FINAL ENVIRONMENTAL ASSESSMENT

***KAPIOLANI REGIONAL PARK  
MASTER PLAN UPDATE***

Waikiki, District of Honolulu, O'ahu, Hawai'i

April 2008

FIGURE 13  
**ALTERNATIVE 'A'**

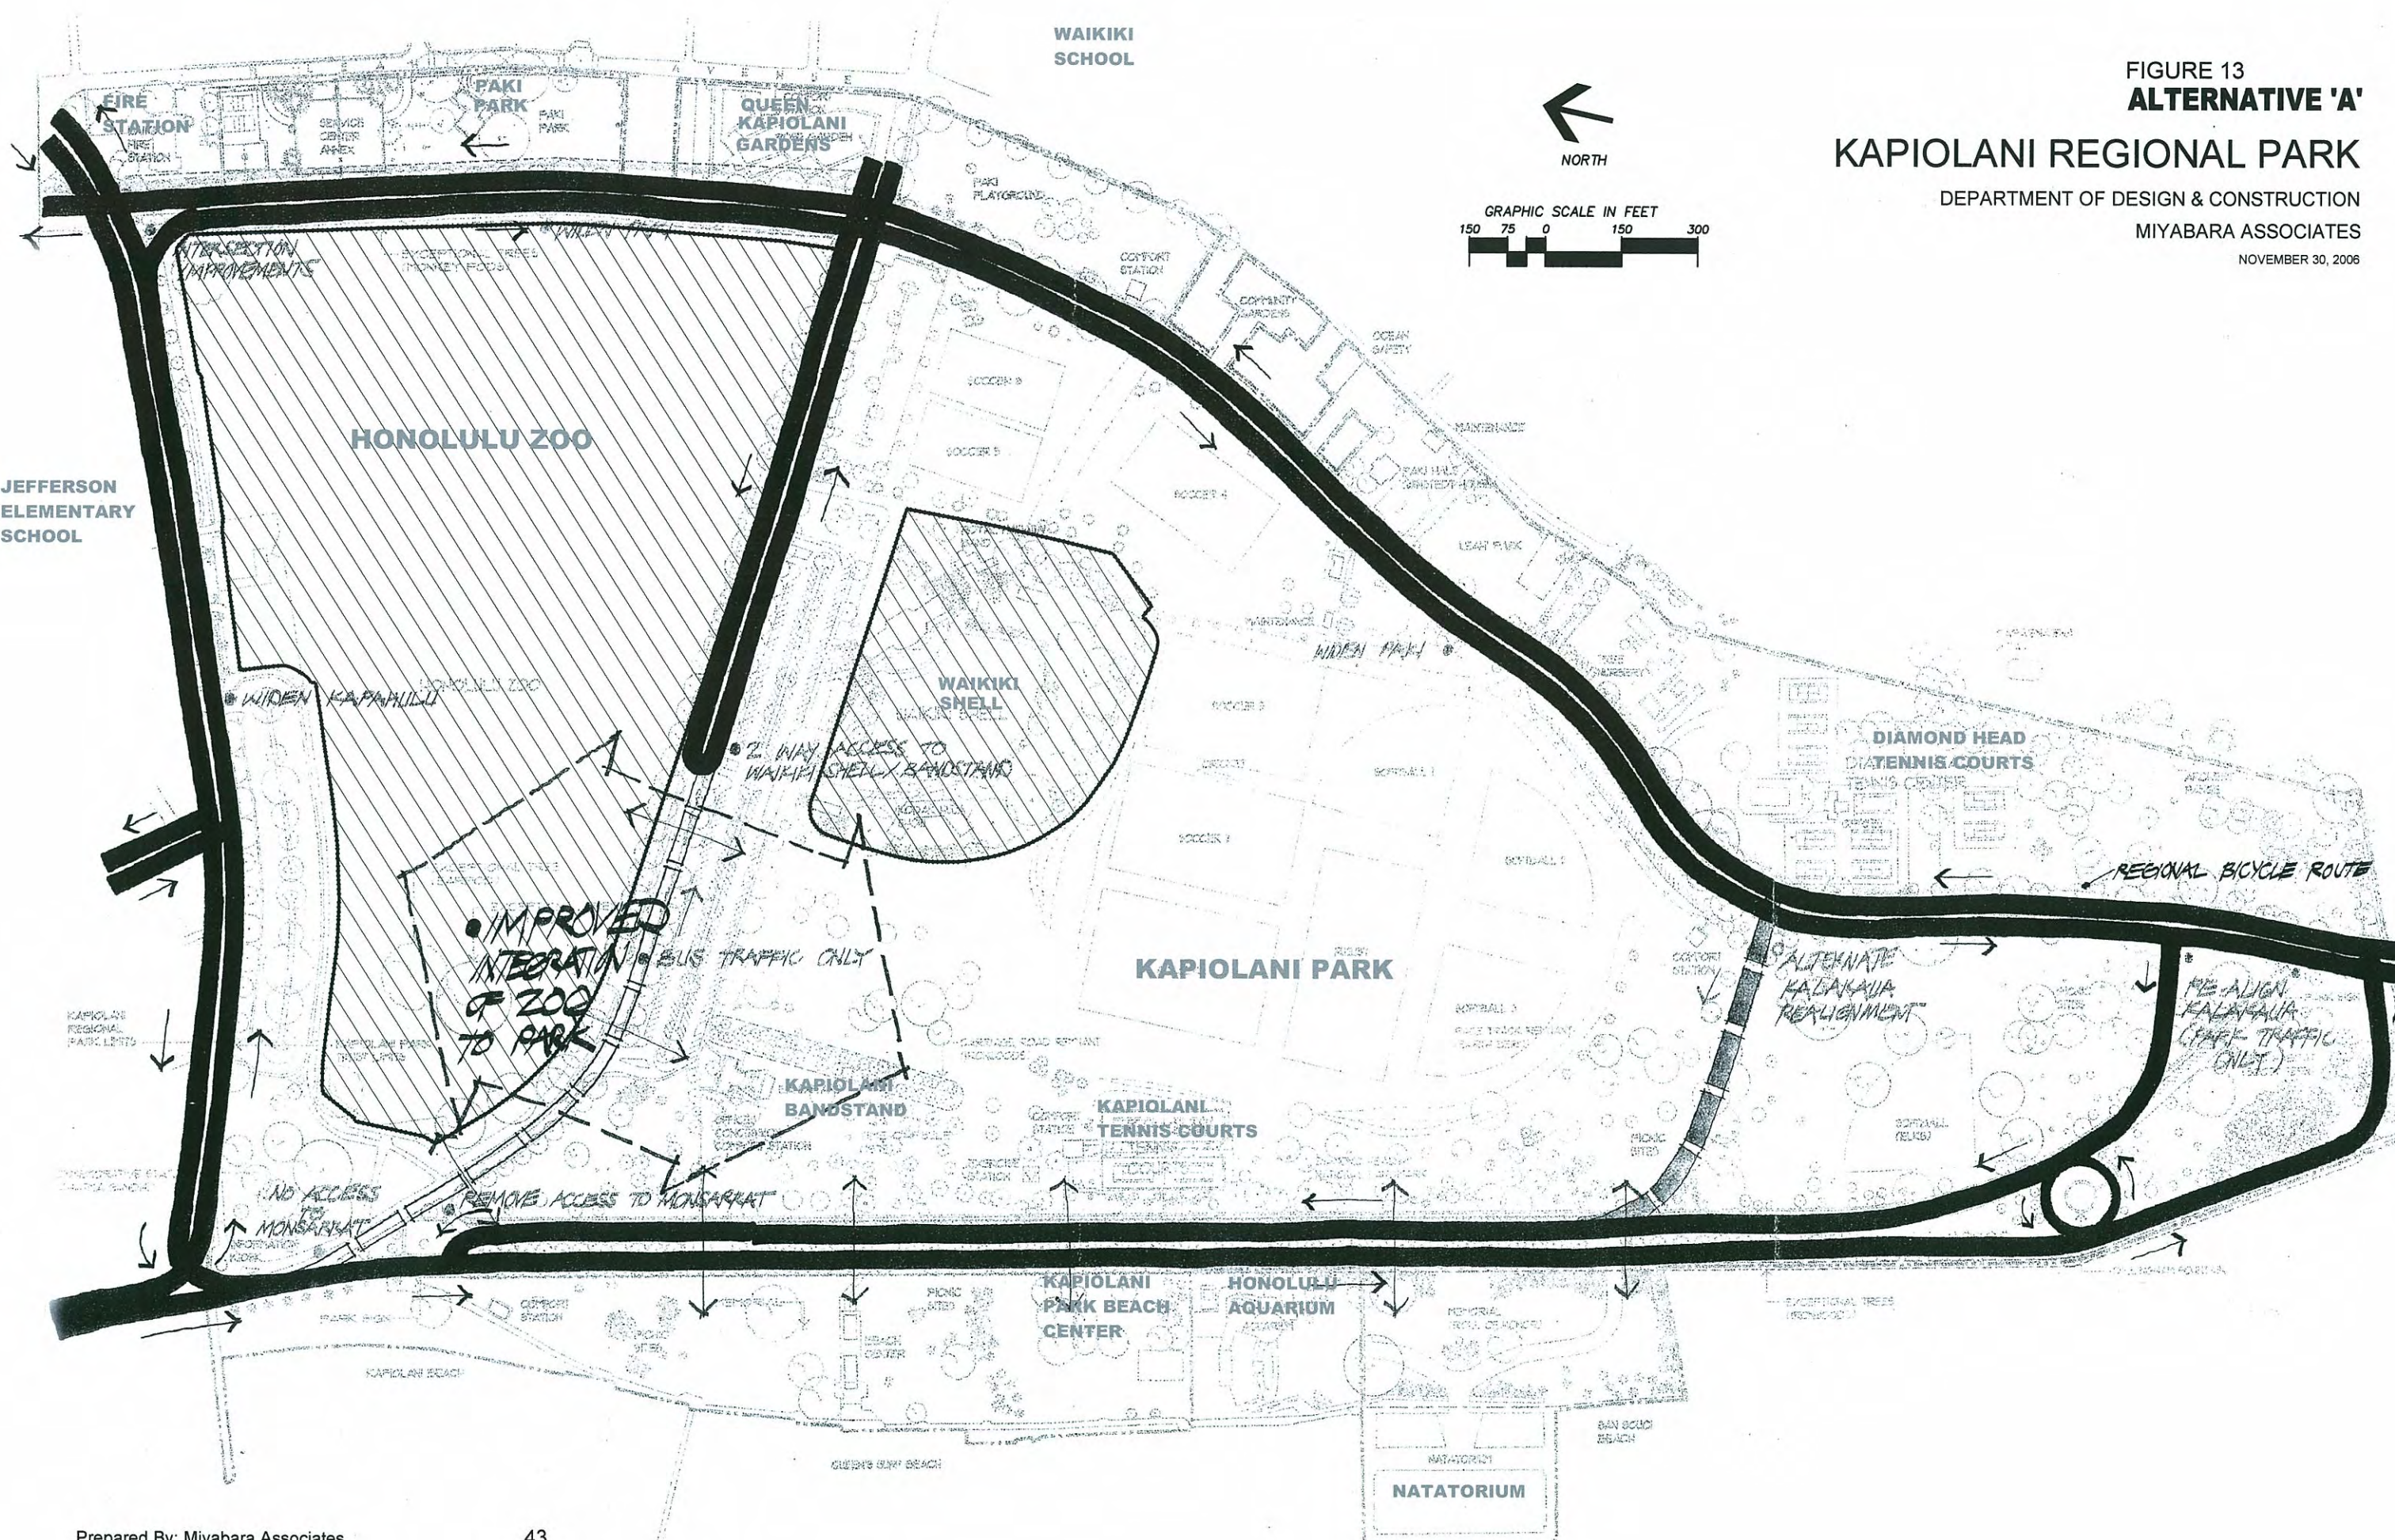
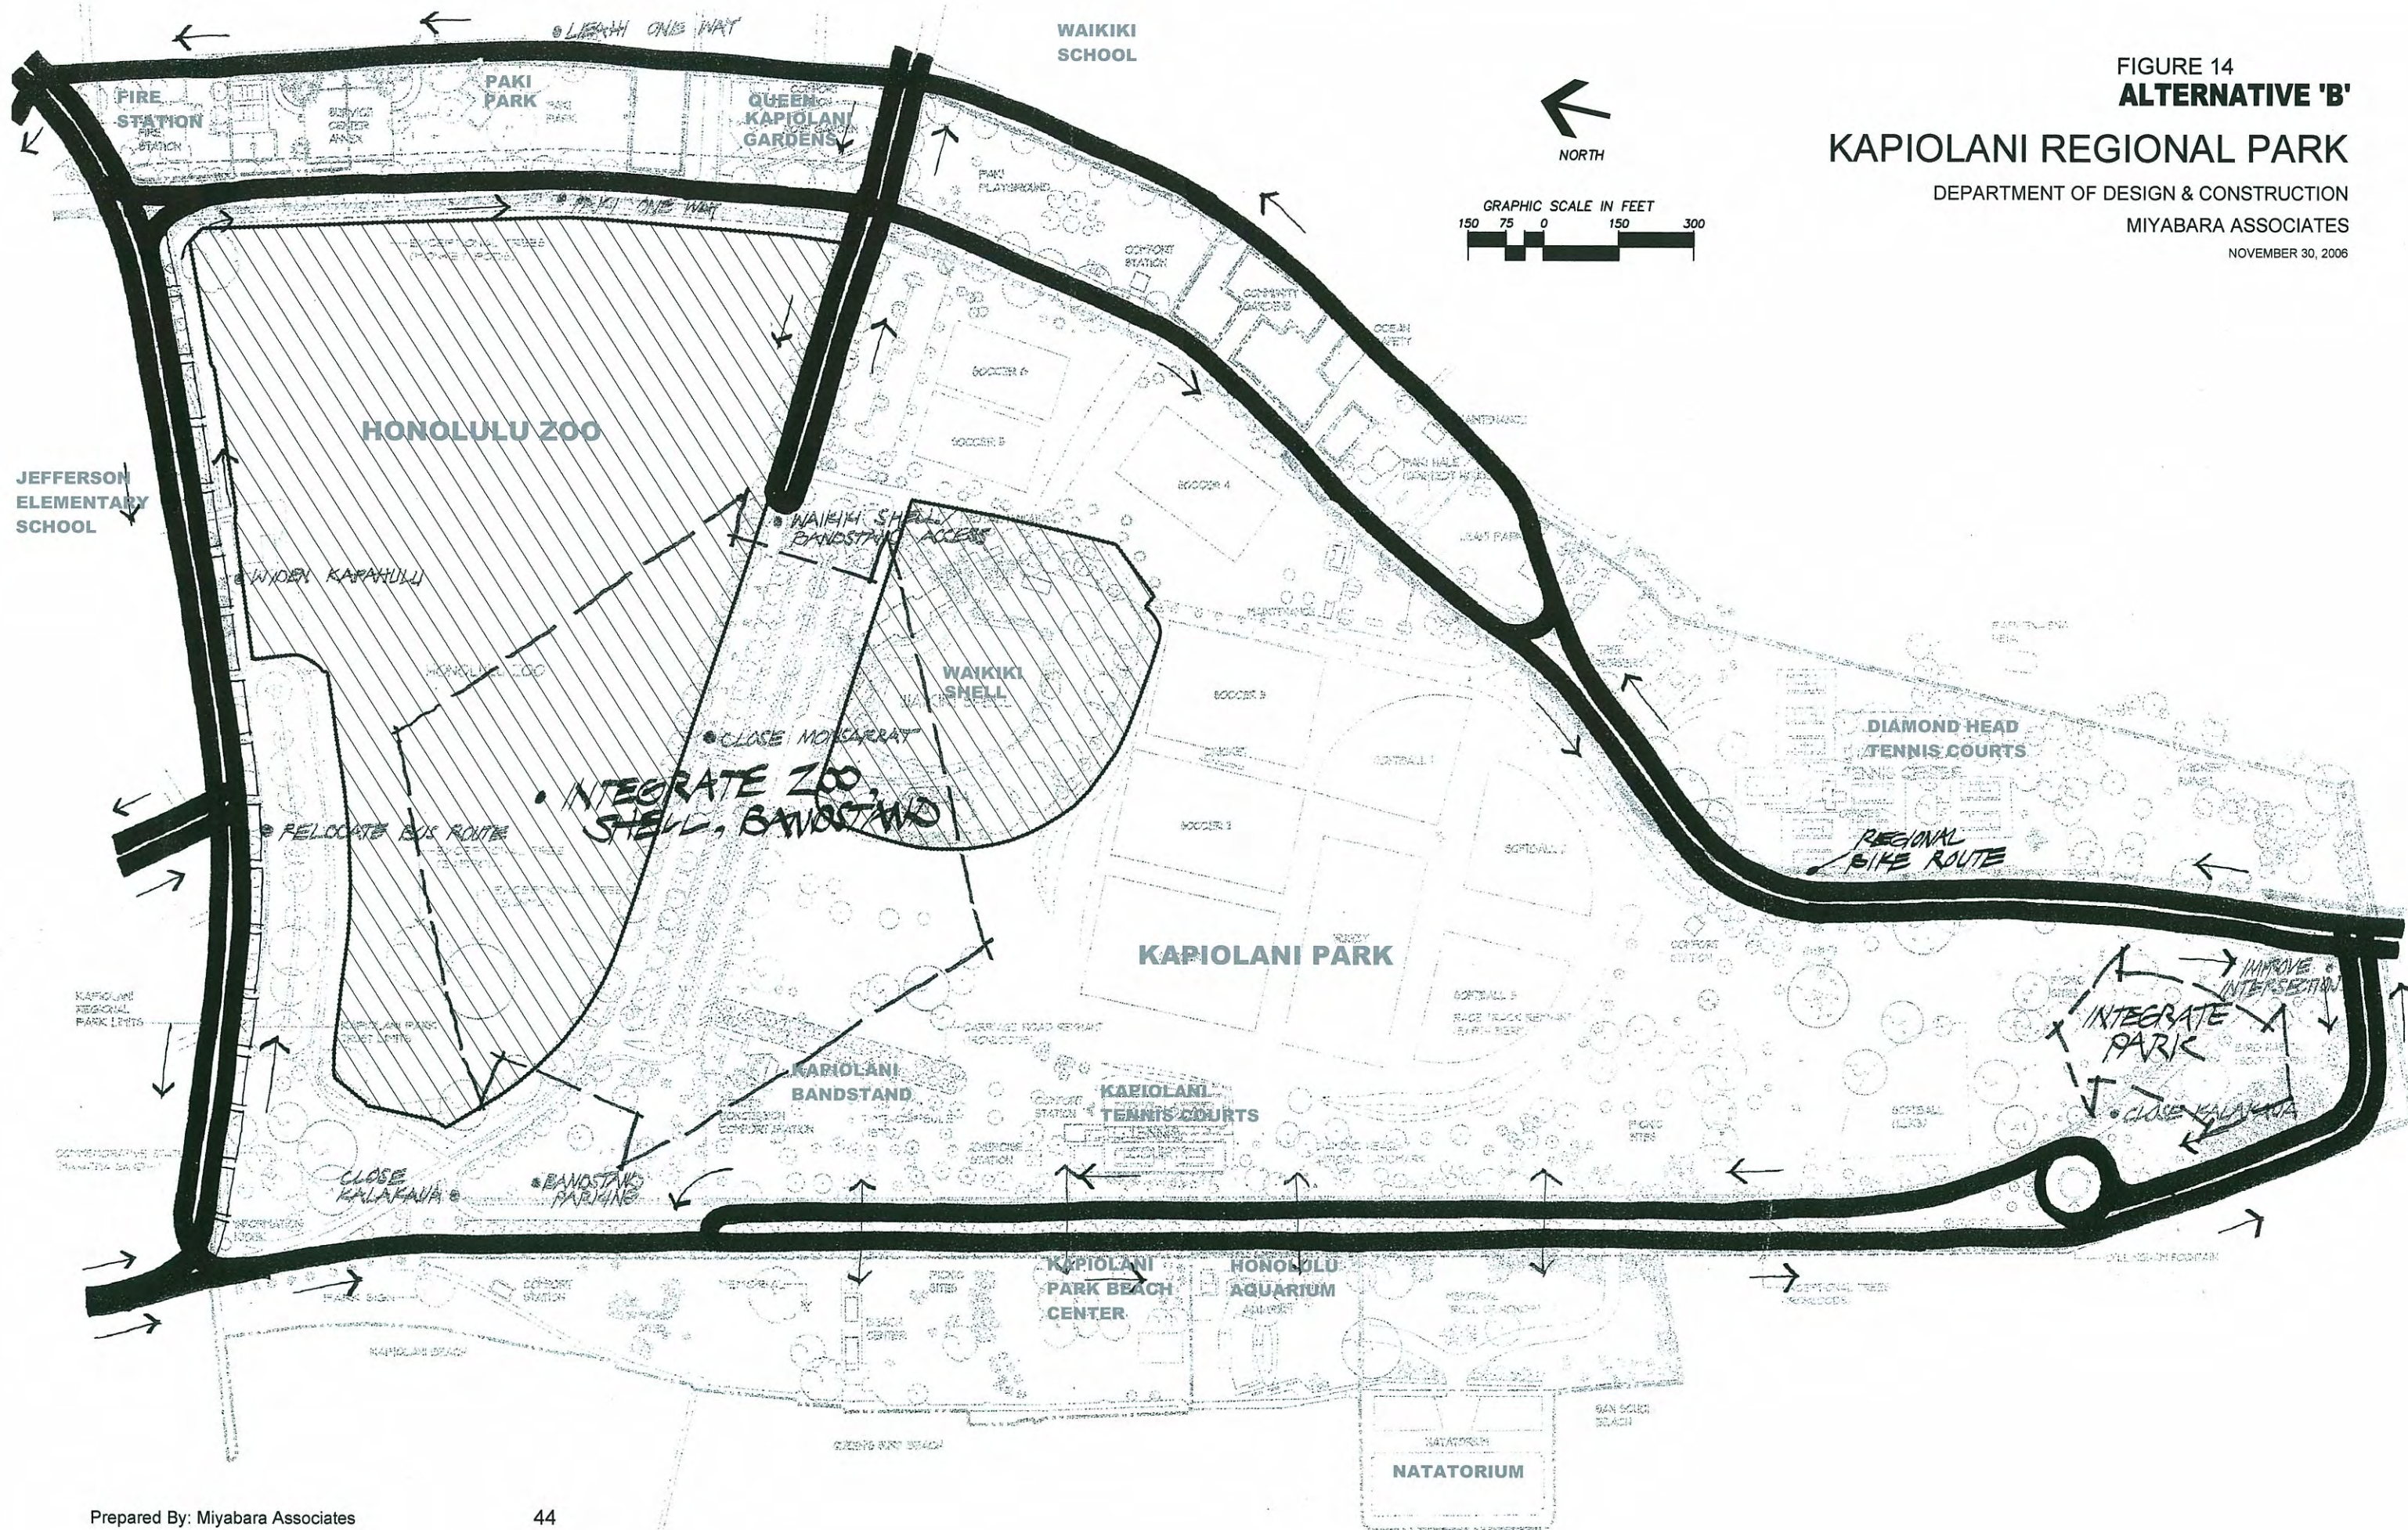
**Keep the Park's traffic circulation pattern as it is. Alternative plans A - D (fig 13-16) are unacceptable and alter the historic character of the Park.**

Circulation Alternatives "A" thru "D" were not selected for implementation in the Kapiolani Regional Park Master Plan Update because changes in existing circulation patterns could affect vehicle circulation beyond the limits of the Park in neighborhoods such as Waikiki, Kapahulu, and Diamond Head. Changes to the existing circulation pattern also would affect bus routes and bus stops on streets in the vicinity of the Park.
